# Access Compliance Report

## Public Rights-of-Way

Intersection ID: 14071	Main Street: CLEVELAND_AV	Cross Street: E_KINGSTON_AV	Location: W
ADA ID: 0F71D223DB02	Ramp Type: Perp	Initial Pass/Fail: Fail	Overall Compliance: No
Severity Score: 22.5			
Codes/Mitigation Info/Possible Solution		Field Measurements/Component Compliance

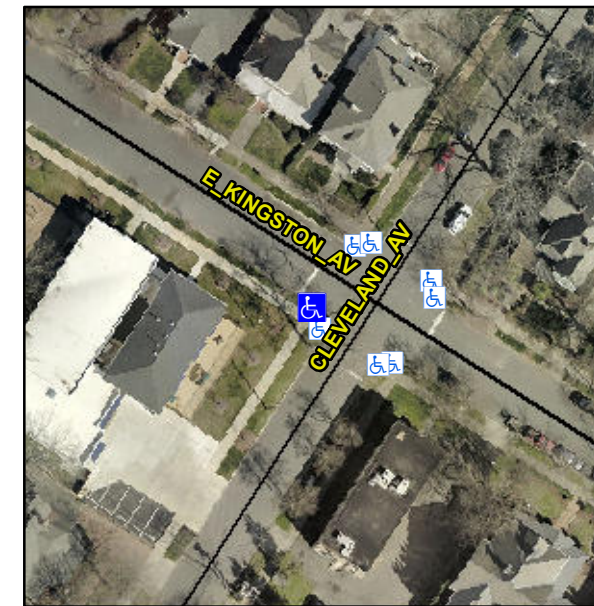
**Remove & Replace Entire Ramp.**

**R304.5.1, R304.2.2, R304.5.3**

Compliance	Description	Data	Compliance	Description	Data
N/A	Ramp Length (in)	53.0	No	Ramp Slope (%)	8.4
No	Ramp Width (in)	36.0	No	Ramp XSlope (%)	3.4
N/A	Flare Type LT	N/A	N/A	Flare Type RT	N/A
N/A	Flare Slope LT (%)	N/A	N/A	Flare Slope RT (%)	N/A
N/A	Flare Traversable LT?	N/A	N/A	Flare Traversable RT?	N/A
N/A	Landing Length (in)	N/A	N/A	DWS Provided?	N/A
N/A	Landing Width (in)	N/A	N/A	DWS Contrast?	N/A
N/A	Landing Slope (%)	N/A	N/A	DWS Length (in)	N/A
N/A	Landing X Slope (%)	N/A	N/A	DWS Full Width?	N/A
N/A	Landing Curb? (Y/N)	N/A	N/A	DWS Offset (in)	N/A
N/A	Shared Landing?	N/A			
N/A	Gutter Ponding?	N/A	N/A	Gutter Slope (%)	N/A
N/A	Gutter Lip Ht (in)	N/A	N/A	Gutter X Slope (%)	N/A
N/A	Painted X Walk1?	No	N/A	Painted X Walk2?	N/A
	X Walk 1 Direction	To NE		X Walk 2 Direction	N/A
N/A	X Walk 1 Width (in)	N/A	N/A	X Walk 2 Width (in)	N/A
	X Walk 1 Slope (%)	2.5		X Walk 2 Slope (%)	N/A
	X Walk 1 X Slope (%)	1.1		X Walk 2 X Slope (%)	N/A
